RE: Special Standards for Hermistons new well #2; SC#32007

RE: City of Hermiston New Well No. 2; SC#32007

City of Hermiston
 New Well No. 2
 by Schneider Drilling Co.
 S.C. #32007

City of Hermiston - New Well No. 2

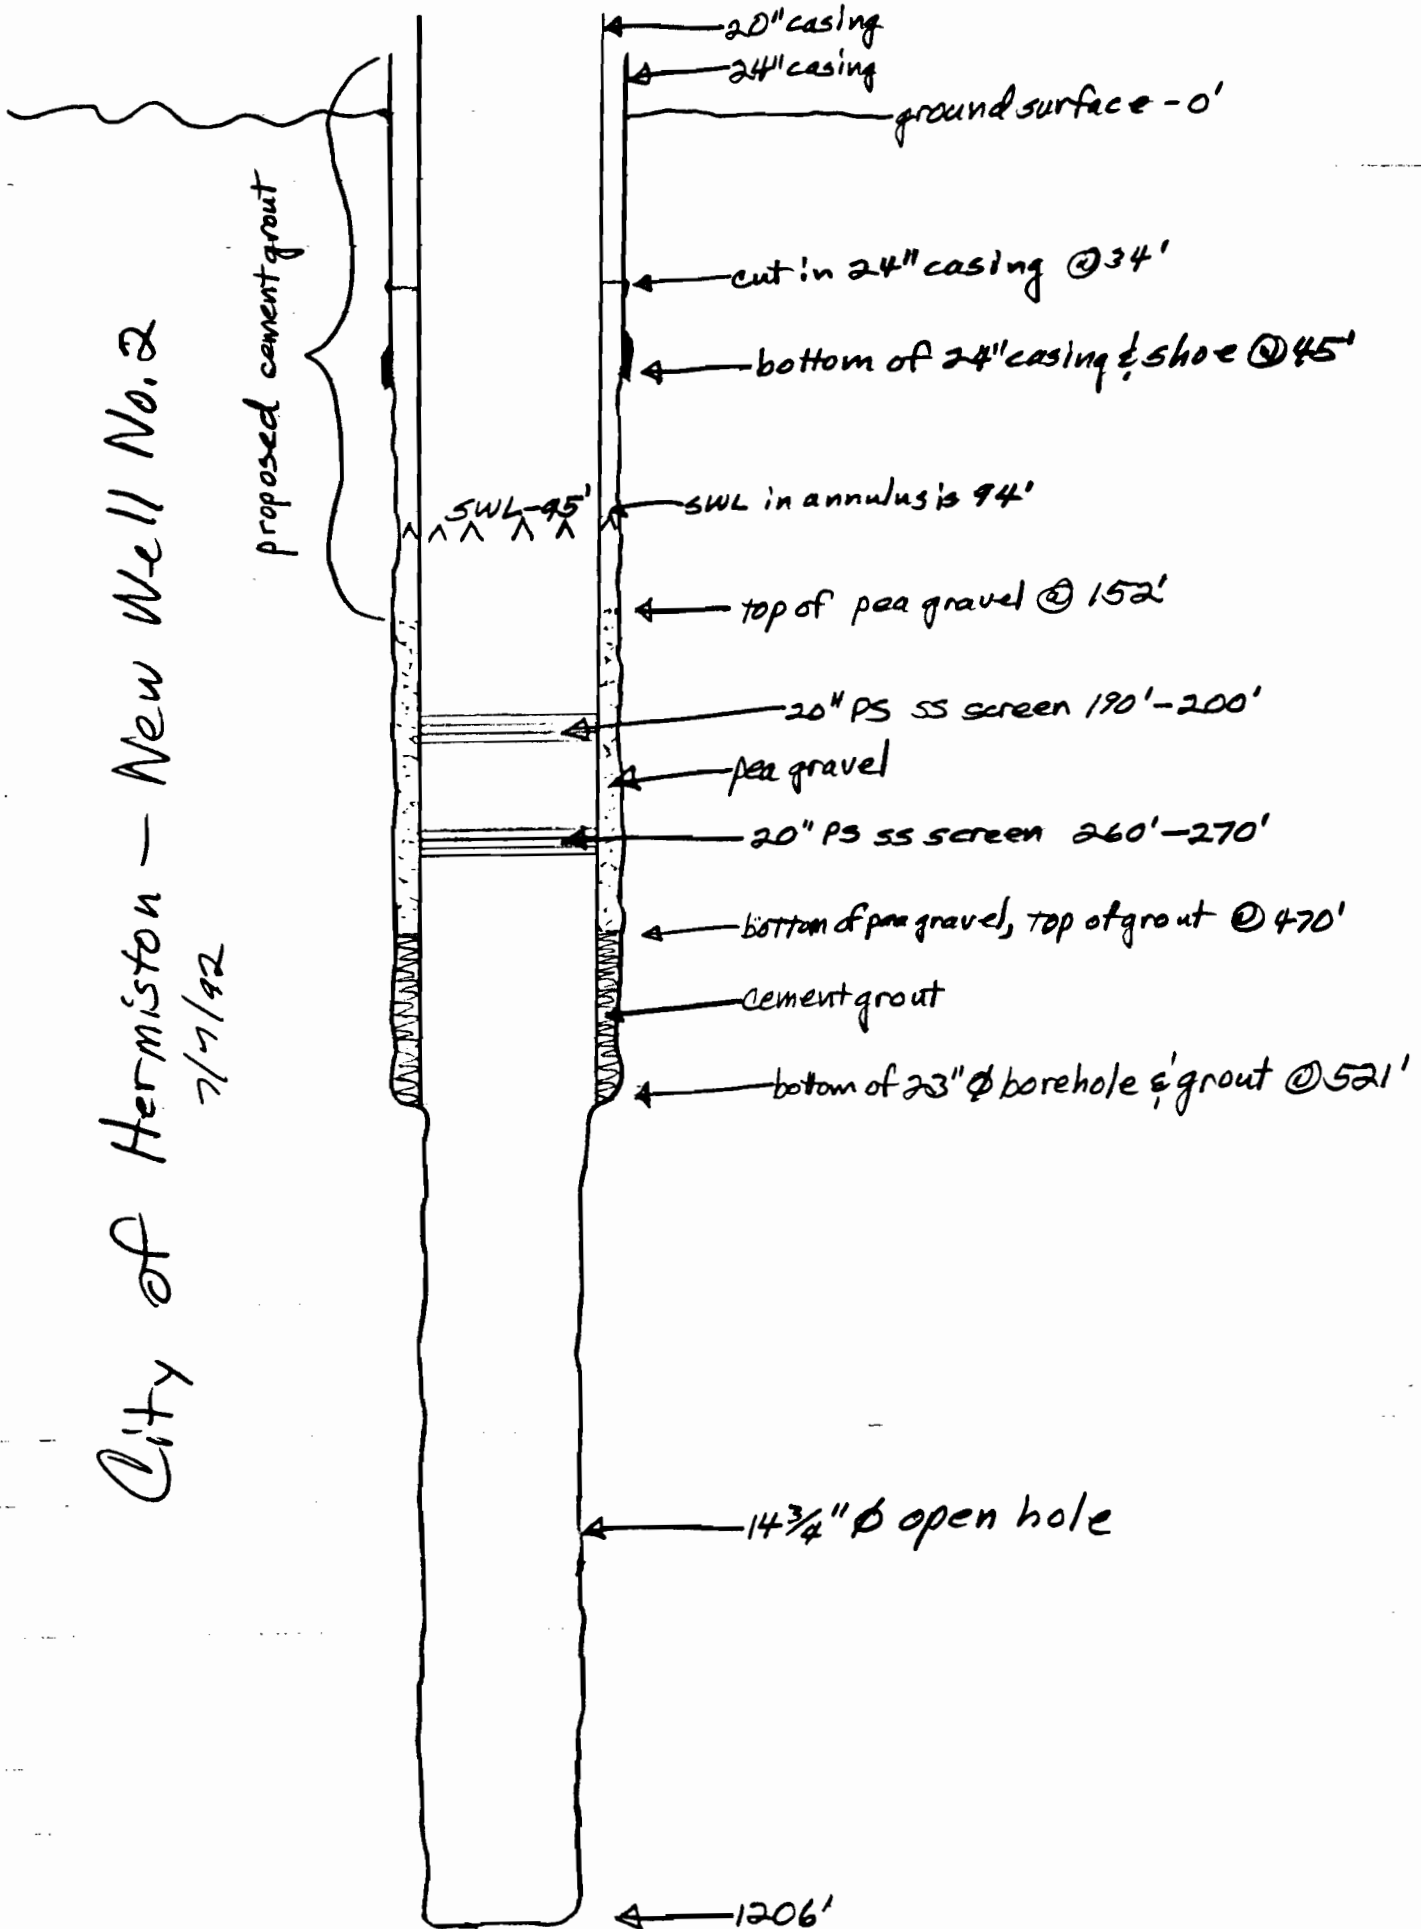
A formation log of the well is attached along with a sketch of the as-built to date. As you can see, a 24" diameter casing was driven as the upper borehole was drilled with cable tool to 45'. The casing was then cut at 34' on August 28, 1991, to aid in future removal during grouting. Subsequently, the rest of the well was constructed during which much vibration occurred along with substantial ground surface loading around the 24" casing. We have now been attempting to extract the 24" upper casing in order to simultaneously place a grout seal around the 20" casing. Our exhaustive efforts have failed even though we have utilized jacks exceeding a half million pounds of pull along with vibration from a down hole hammer. We have taxed/exceeded normal water well technology standards.

No additional water resource protection will be gained by extracting, or attempting to extract the 24" casing. The only alluvial water bearing within the depth of the 24" casing is that which is exposed to the surface and only extends to 15'. This shallow formation would not benefit from a standard 18' surface seal since it is directly connected to ground surface. Disturbing the 24" casing will only damage an otherwise very pronounced bond (seal) to the natural formation. We therefore

propose to leave the 24" casing in place and pump a cement grout seal full depth from the top of the pea gravel (150') to the surface, around the 20" casing. This will provide more than standard protection for the waters in the basalt. Will this meet with your approval?

This is written conformation approving the special standards granted to you by phone on July 10, 1992 by Brian Mayer.

This standard is granted upon the condition that the well be completed as detailed in your letter dated July 07, 1992, a copy of which is attached.
